FED. ROAD DIST. NO.	STATE	FED. AID PROJ. NO.	FISCAL YEAR	SHEET NO.	TOTAL SHEETS
HAWAII	HAW.	BR-083-1(27)	1998	ADD.8	58

"AS-BUILT"

C.O.ADD. 8

PLAN

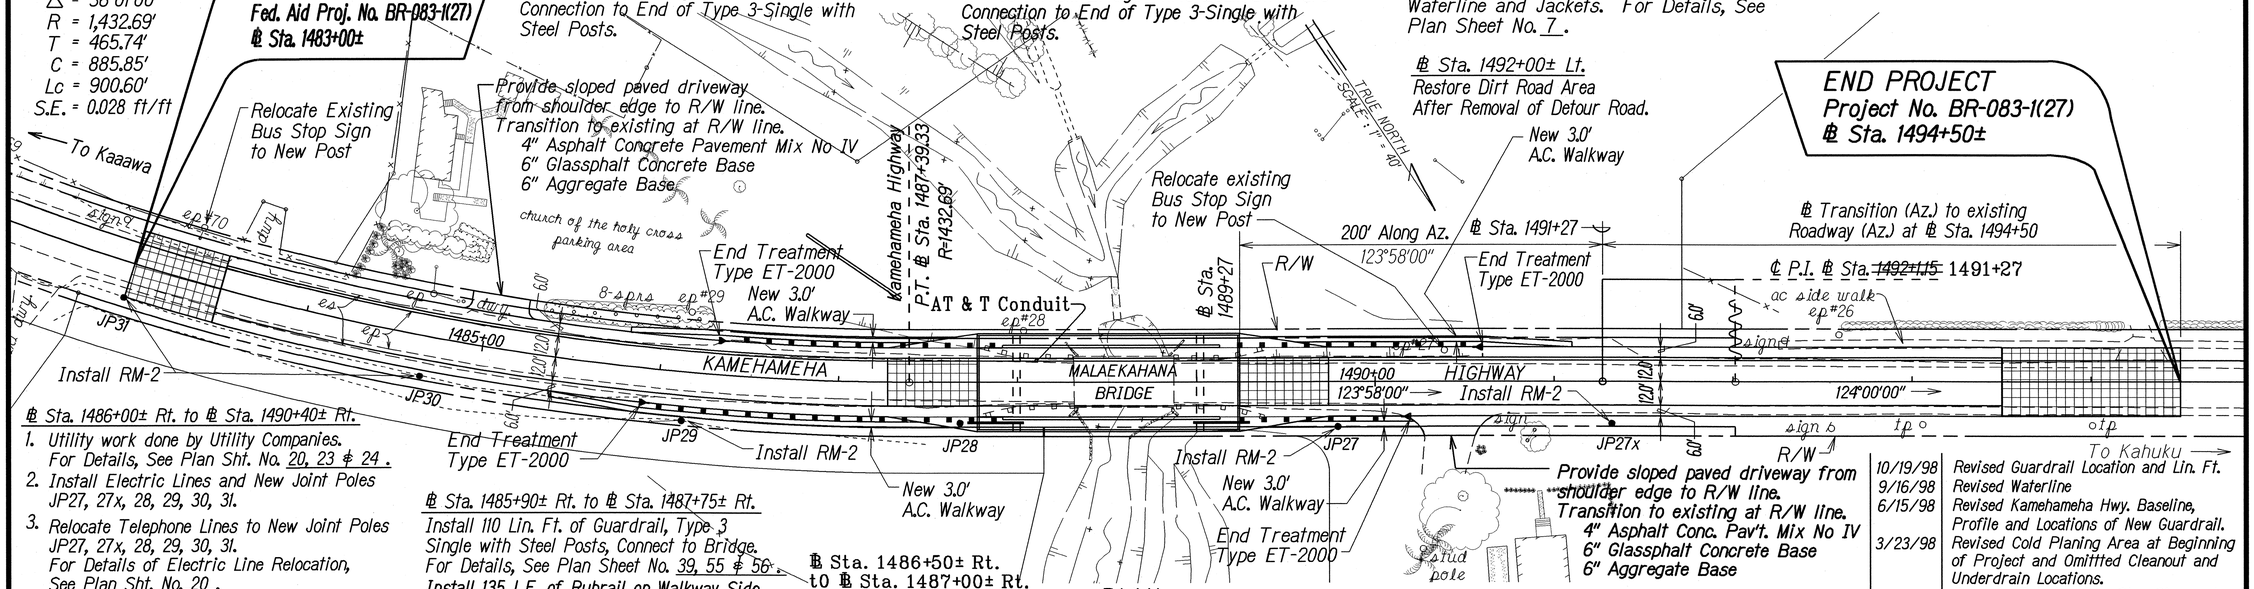
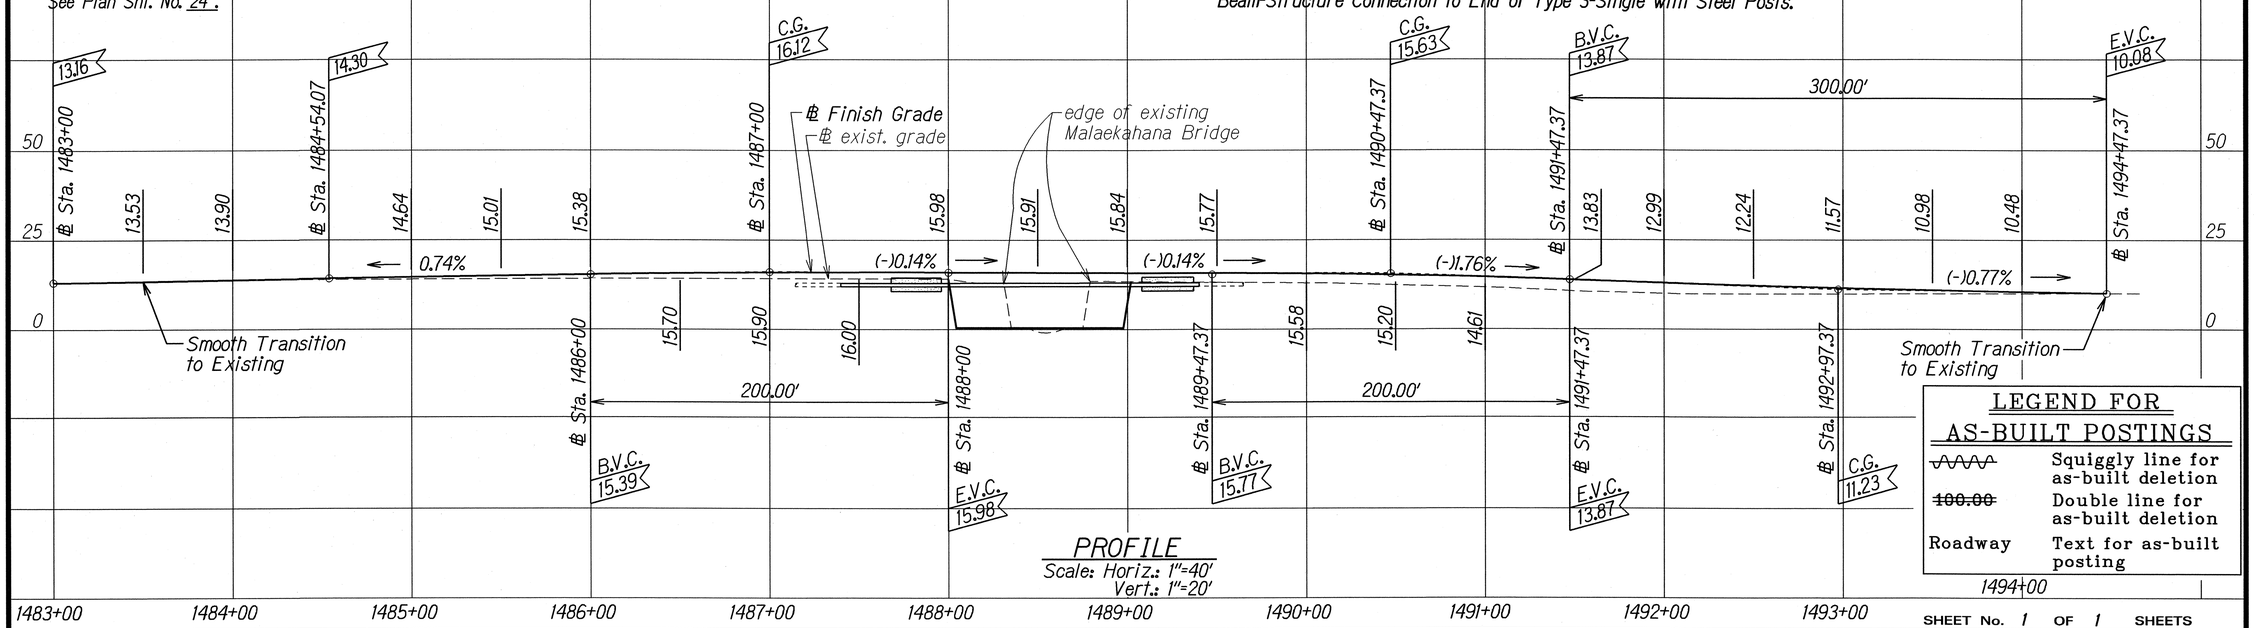
℄ Sta. 1486+30± Lt. to ℄ Sta. 1487+75± Lt.
Install 70 Lin. Ft. of Guardrail, Type 3 Single with Steel Posts, Connect to Bridge. For Details, See Plan Sheet No. 39, 55 & 56 .
Install 95 L.F. of Rubrail on Walkway Side of Posts from Bridge Thrie Beam-Structure Connection to End of Type 3-Single with Steel Posts.

℄ Sta. 1489+27± Lt. to ℄ Sta. 1490+60± Lt.
Install 58 Lin. Ft. of Guardrail, Type 3 Single with Steel Posts, Connect to Bridge. For Details, See Plan Sheet No. 39, 55 & 56 .
Install 83 L.F. of Rubrail on Walkway Side of Posts from Bridge Thrie Beam-Structure Connection to End of Type 3-Single with Steel Posts.

℄ Sta. 1488+00± Lt. to ℄ Sta. 1489+02± Lt.
Demolish and Remove Existing Bridge. Construct New Girder Bridge with Reinforced Concrete Approaches. For Details, See Plan Sheet No. 33 .
Install New ~~Jacketed 12" Waterline Bends,~~ Waterline and Jackets. For Details, See Plan Sheet No. 7 .

℄ Sta. 1485+90± Rt. to ℄ Sta. 1487+75± Rt.
Install 110 Lin. Ft. of Guardrail, Type 3 Single with Steel Posts, Connect to Bridge. For Details, See Plan Sheet No. 39, 55 & 56 .
Install 135 L.F. of Rubrail on Walkway Side of Posts from Bridge Thrie Beam-Structure Connection to End of Type 3-Single with Steel Posts.

℄ Sta. 1486+50± Rt. to ℄ Sta. 1487+00± Rt.
Replace 50 L.F. of exist. guardrail, type 3 single w/ steel posts w/ New Thrie beam Rail.

℄ Sta. 1489+27± Rt. to ℄ Sta. 1490+10± Rt.
Install 8 Lin. Ft. of Guardrail, Type 3 Single with Steel Posts, Connect to Bridge. For Details, See Plan Sheet No. 39, 55 & 56 .
Install 33 L.F. of Rubrail on Walkway Side of Posts from Bridge Thrie Beam-Structure Connection to End of Type 3-Single with Steel Posts.

DATE	REVISION
10/19/98	Revised Guardrail Location and Lin. Ft.
9/16/98	Revised Waterline
6/15/98	Revised Kamehameha Hwy. Baseline, Profile and Locations of New Guardrail.
3/23/98	Revised Cold Planing Area at Beginning of Project and Omittted Cleanout and Underdrain Locations. Relocate Existing Bus Stop Sign and Added Note Install RM-2 and a New 3.0' A.C. Walkway.
